## UNITED STATES ENVIRONMENTAL PROTECTION AGENCY REGION IX

March 19, 2017

Re: E PA Comments on Atlantic Richfield's Draft Final Focused Remedial Investigation Work Plan Amendment No. 12—Task Sampling and Analysis Plan for Hydrocarbon Investigation, Leviathan Mine Site, Alpine County, California, dated June 1, 2016

Photo 1: Work Area. Drums stored on site.

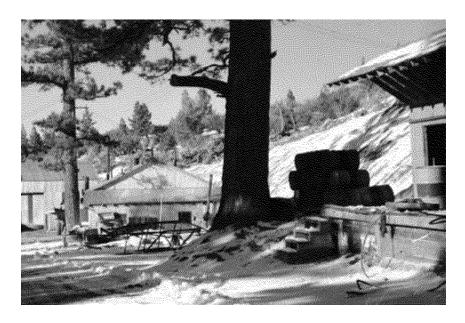
- o *ARC's response fails to address EPA's concern.* Lack of documentation does not suggest that petroleum or other products were not used at the site. Historical photographs (i.e. See attached photo 1) clearly document stacked drums along the side of the access road between Leviathan Mine Road and the current Aspen Seep entrance. As previously requested on April 29, 2016, and during our March 17, 2017 phone call, ARC shall investigate for the presence of TPH in this area with known historical maintenance activities. Please provide a sampling plan with a limited number of samples sufficient to investigate this area (ARC suggested approximately 20 samples). This work shall be completed during the 2017 field season.

Within 30 days or by April 30, 2017; EPA directs ARC to provide a samplin g locations map within the historical equipment maintenance area (Fi gure 1), and a table showing the requested TPH thresholds for determining the need for additional investigation. Please also provide a schedule for completing this field sampling and associated reporting by June 30, 2017.

Figure 1: Approximate area containing former equipment sheds and drums based on photographs. Note that this area should be confirmed through brief reconnaissance, field inspection, and discussion with the property owner, Lahontan Regional Water Quality Control Board, prior to sampling.

EPA understands that approximately 20 samples may be required, but expects that more accurate identification of the area will assist in identifying the area, and the actual number, location, and depths of samples.
